NETWORK ANALYZER 8407A

OPERATING AND SERVICE MANUAL

Serial Prefix: 1144A

For serial prefixes above 1144A, a "Manual Changes" sheet is included with this manual. For serial prefixes below 1144A, see Appendix I.

Figure 7-28. Parts Location for Programmable IF Attenuator A7 (Change F, Serial No. 972-00385 and Below)

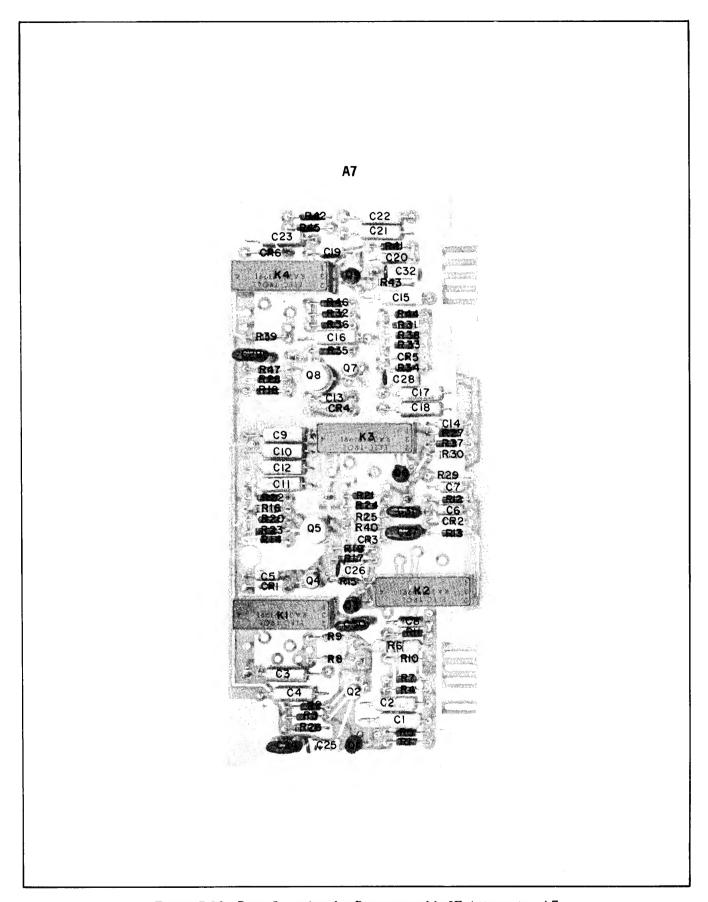
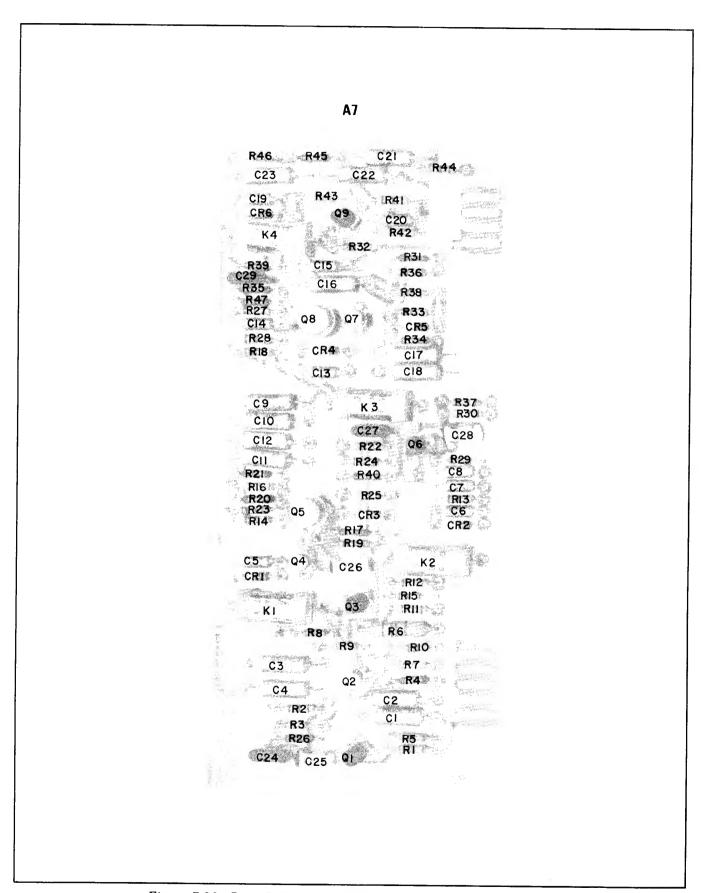
Change A7C25 to HP Part No. 0160-2250, C: FXD CER 5.1-0.25 PF 500 VDCW.

Delete A7C30-A7C33.

Change A7K1—A7K4 to HP Part No. 0490-0760, RELAY: REED 0.1 AMP MAX. 250V MIN. Recommended replacement is 0490-0884.

Page 7-29, Figures 7-28 and 7-29:

Replace Figure 7-28 and Figure 7-29 in Section VII of Manual with Figures 7-28 and 7-29 (Change F) in this Appendix.

Figure 7-31. Front Panel Assembly A1 and A2, Schematic Diagram

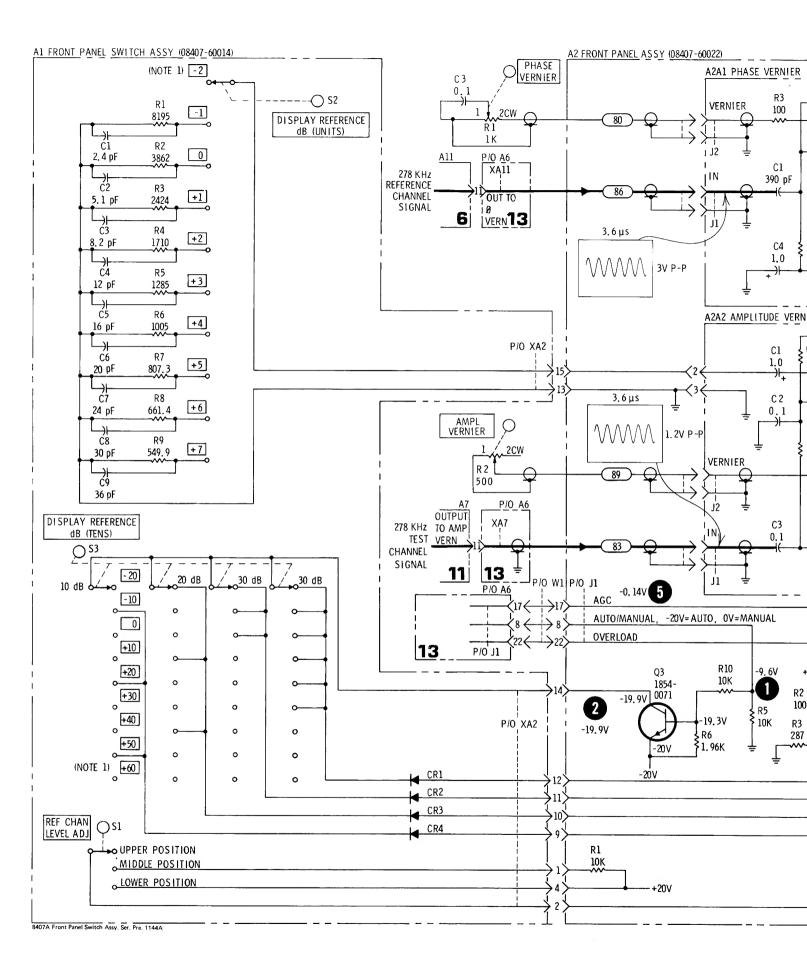
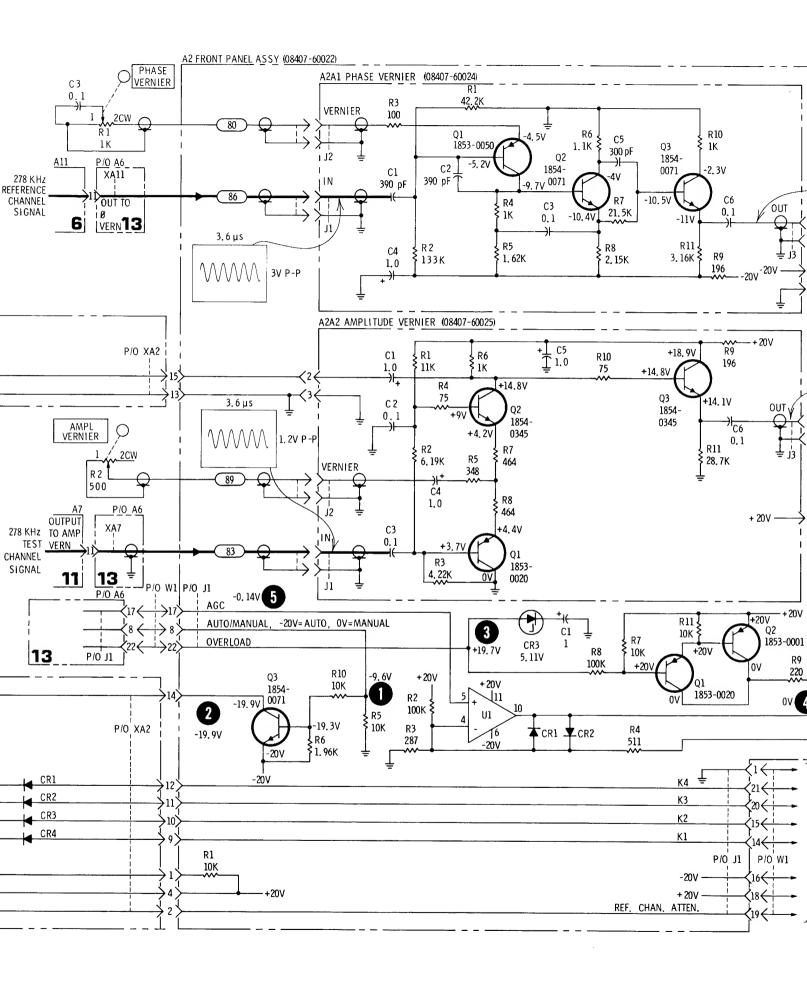
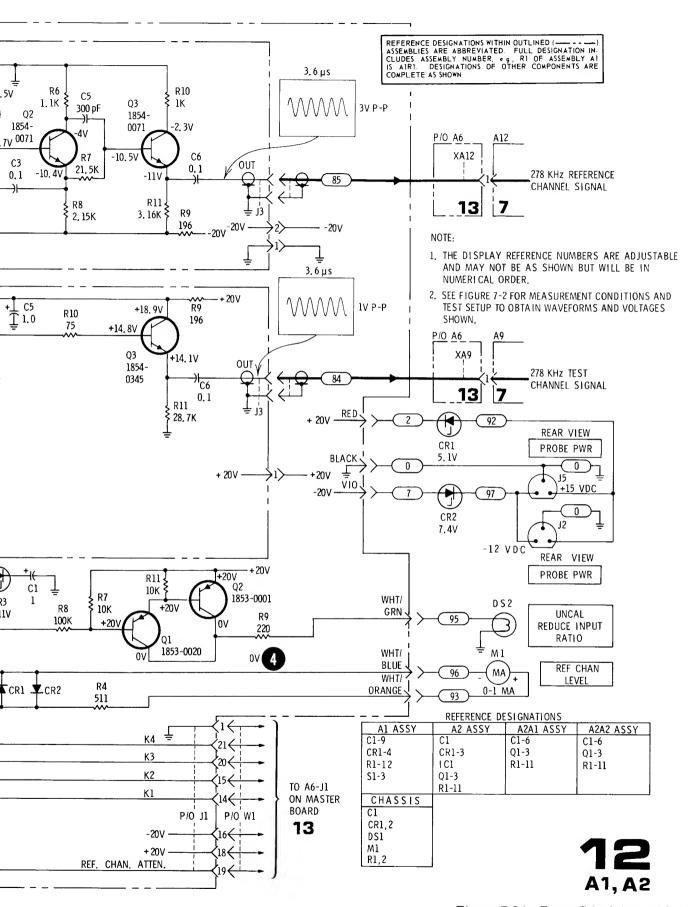
Page 7-31, Figure 7-31:

Change A2R3 to 261 OHMS.

Figure 7-34. Parts Location for Diode Board A5 and Power Supply A17 (Change H, Serial No. 959-00245 and Below)

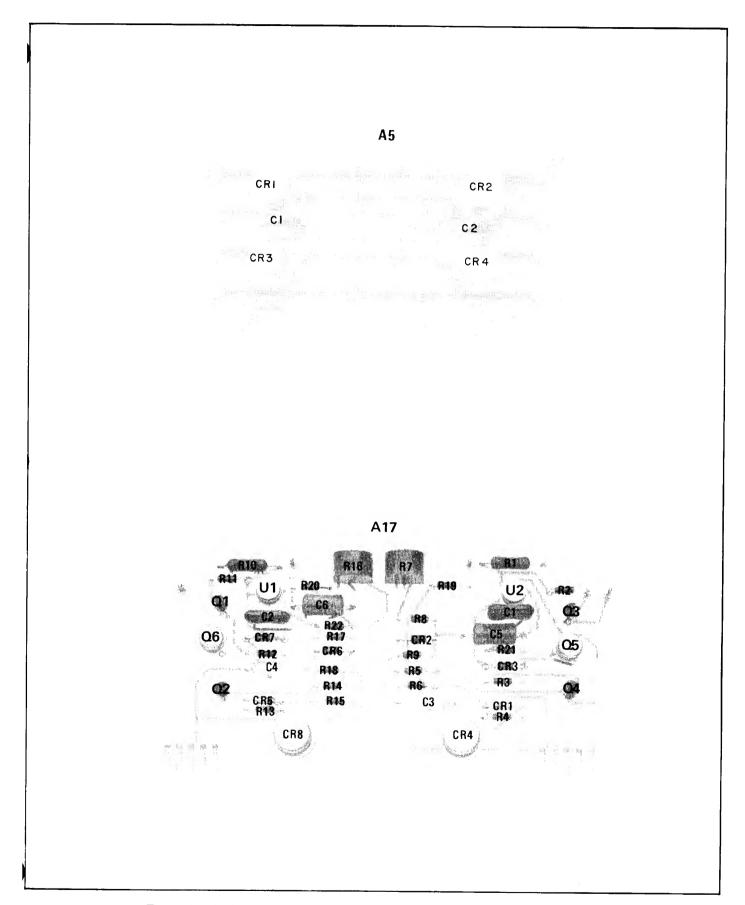
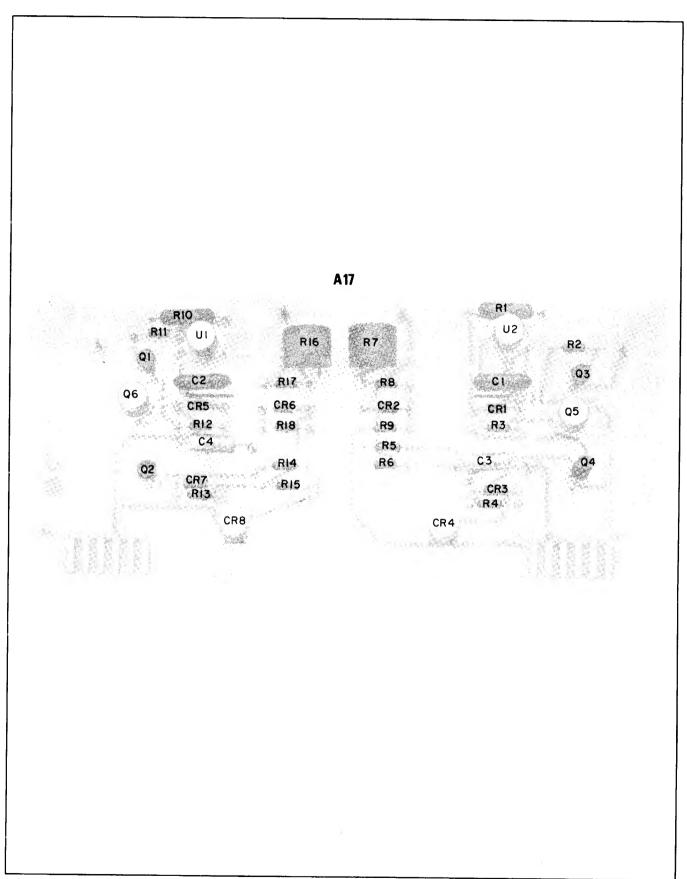
Replace Figures 7-34 and 7-35 in Section VII of manual with Figures 7-34 and 7-35 (Change H) in this Appendix.

Figure 7-35. Power Supply A17 and Diode Board A5, Schematic Diagram

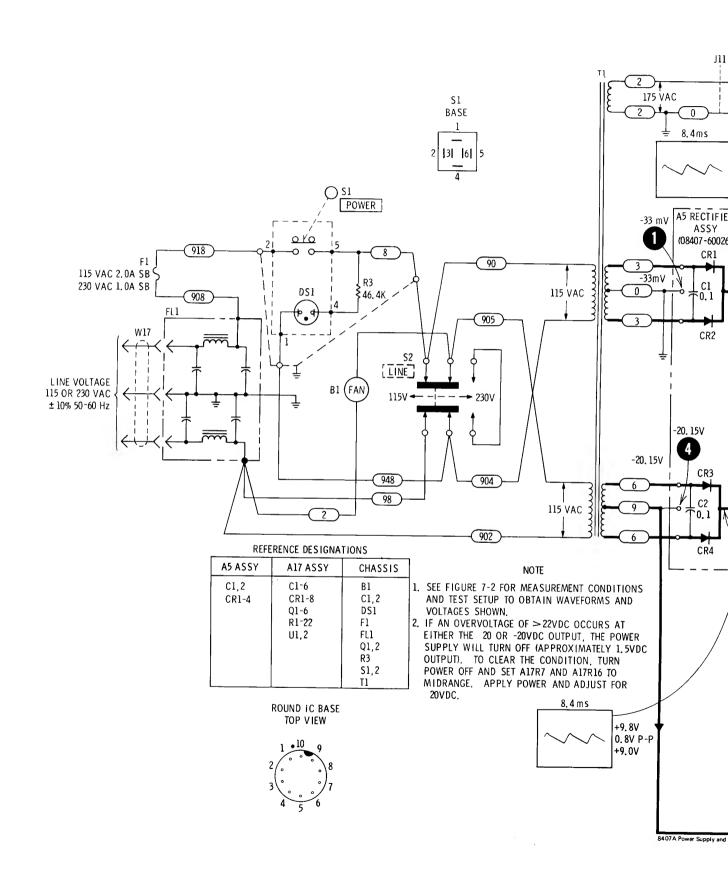
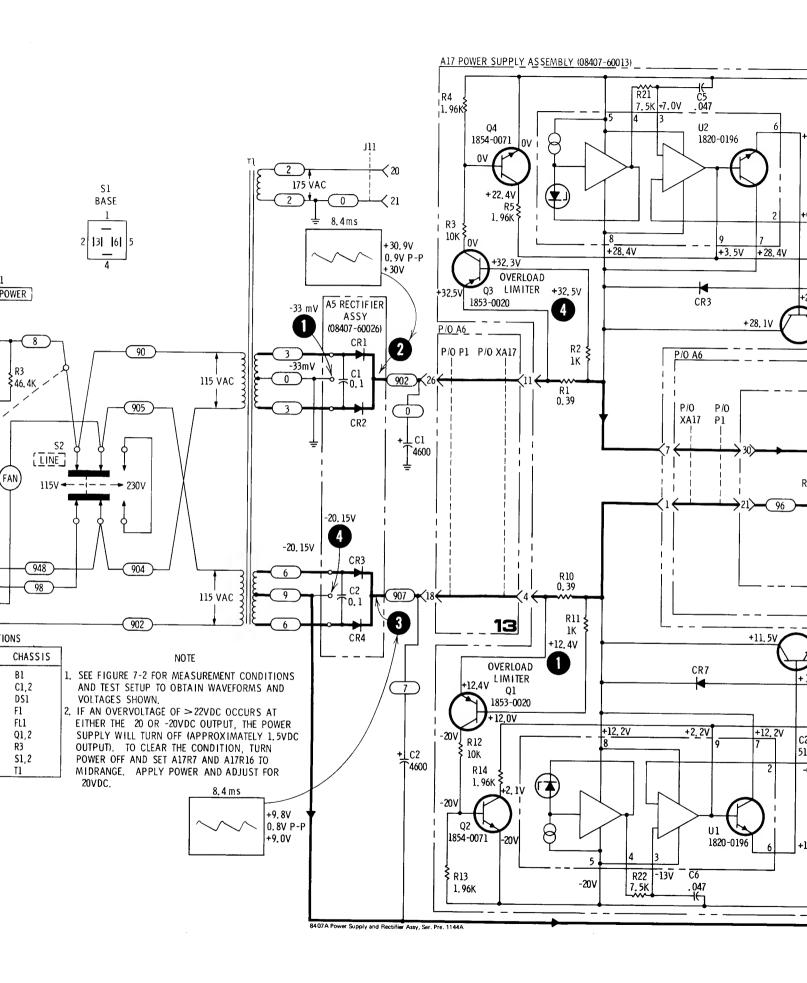
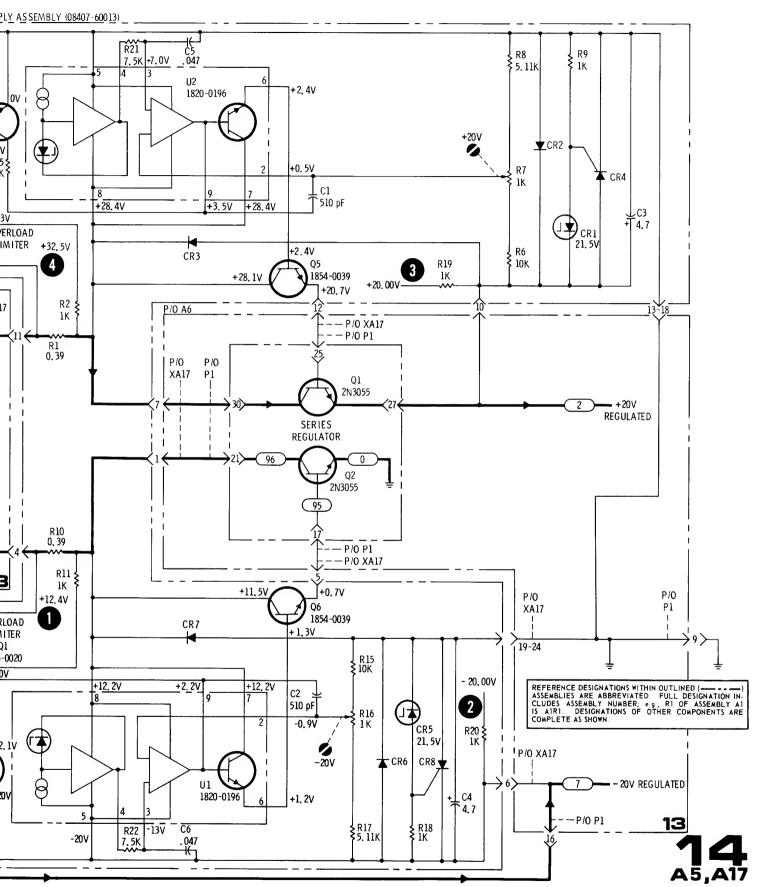
Page 7-35, Figure 7-35:

Change A5C1 and C2 to 0.01 UF.

Page 7-35, Figure 7-35:

Change A17R1 and A17R10 to 0.25 OHMS.

Page 7-35, Figure 7-35: Delete A17C3 and A17C4.

Figure 7-14. Parts Location for Phase-Locked Oscillator A14 (Change E, Serial No. 948-00176 thru 983-00445)

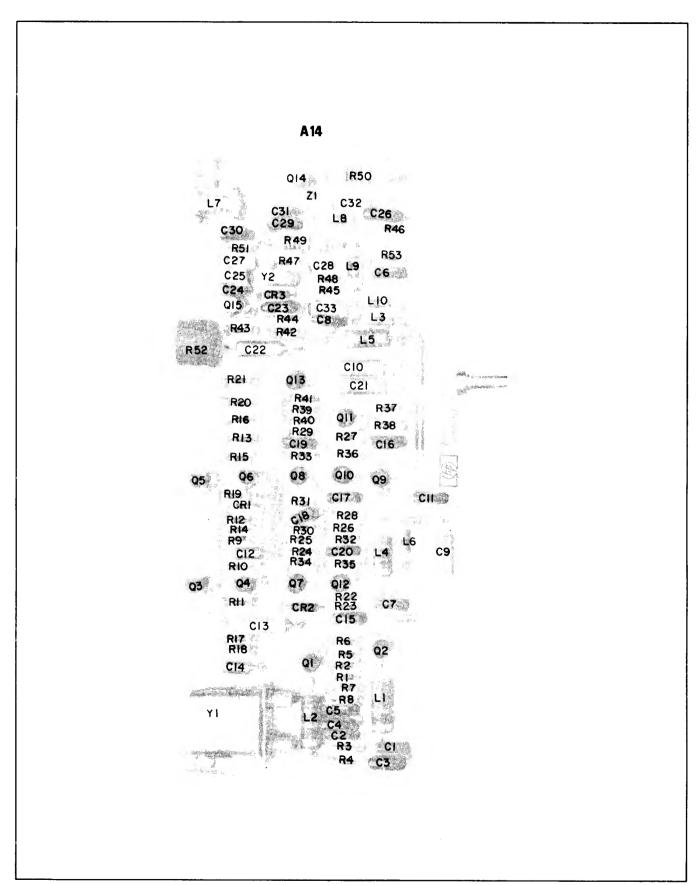
Replace Figure 7-14 and Figure 7-15 in Section VII of Manual with Figures 7-14 and 7-15 (Change E) in this Appendix.

Figure 7-14. Parts Location for Phase-Locked Oscillator A14 (Change I, Serial No. 924-00131 thru 948-00175

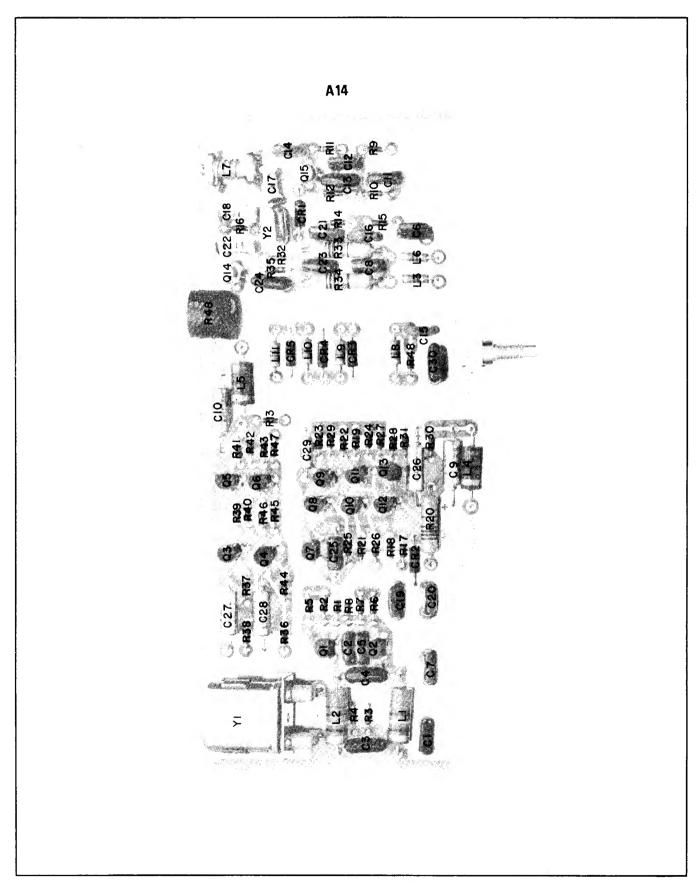
Change A14 to HP Part No. 08407-60009 and also change all of the associated A14 board components per the attached parts list. If it is necessary to replace A14, it should be replaced with HP Part No. 08407-60123 or 08407-60107 (rebuilt). At the same time A13 must be replaced with 08407-60002 or 08407-60102 (rebuilt).

Change parts location photo and circuit board schematic of A14 per attached Figures 7-14 and 7-15.

Figure 7-14. Parts Location for Phase-Locked Oscillator A14 (Change L, Serial No. 924-00130 and Below)

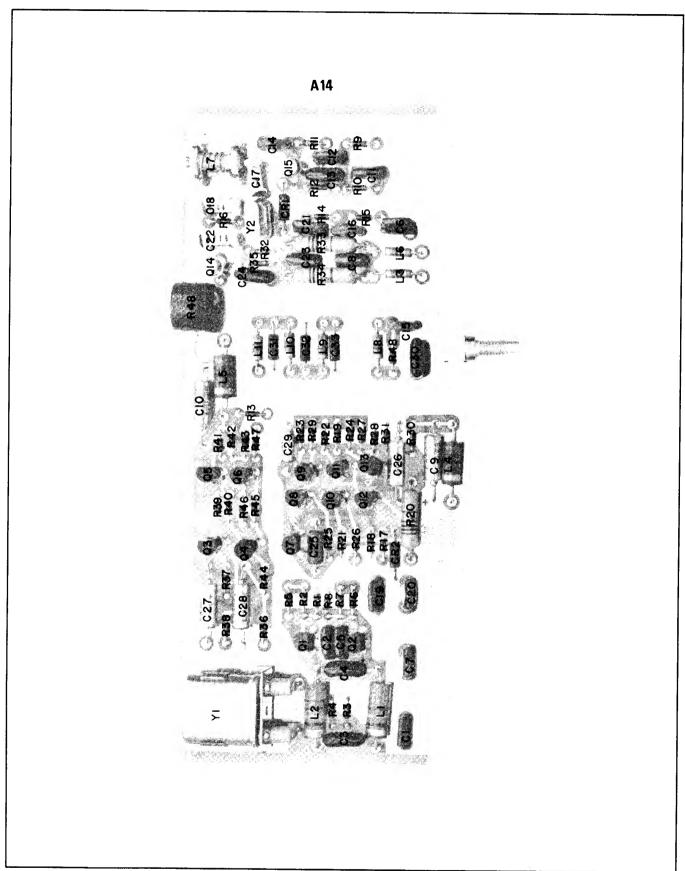
Add A14CR3, 4, and 5, HP Part No. 0122-0201, C: VOLTAGE VAR 15 pF 10% 30WV.

Delete A14C31, 32, and 33.

Change A14R16 to HP Part No. 0698-7224, R: FXD FLM 316 OHM 2% 1/8W.

On Figure 7-15 (Change I) included with this appendix:

Delete A14C31, C32, and C33; put in their place A14CR3, CR4, and CR5; all 15 pF voltages variable capacitors with cathodes wired to ground.

Add a yellow wire connecting XA13 pin 9 to XA14 pin 16.
